Project: Pier A – River Water Geothermal  
System Maintenance

RE: Addendum #1

**EXISTING PLAN**  
SCALE: 3/8" = 1'-0"

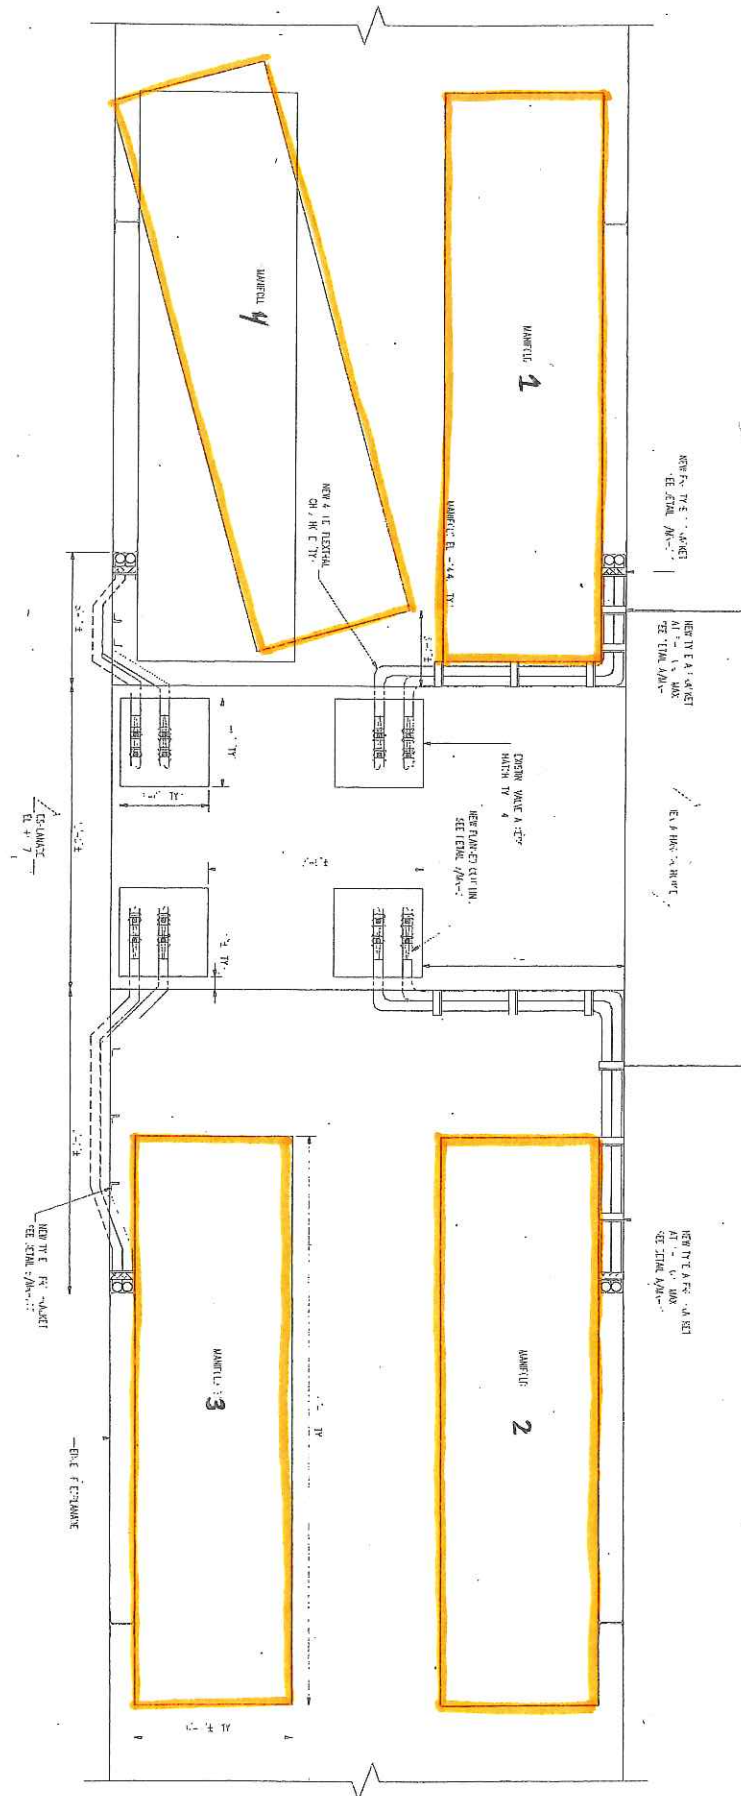
- 1) Can you provide plans showing the location, details and weights of the arrays to be maintained?

*The array location diagram may be found on pages 2 and 3 attached hereto, while pages 4 through 10 contain the details and specifications for the arrays.*

*Each array weighs approximately 6,500 lbs.*
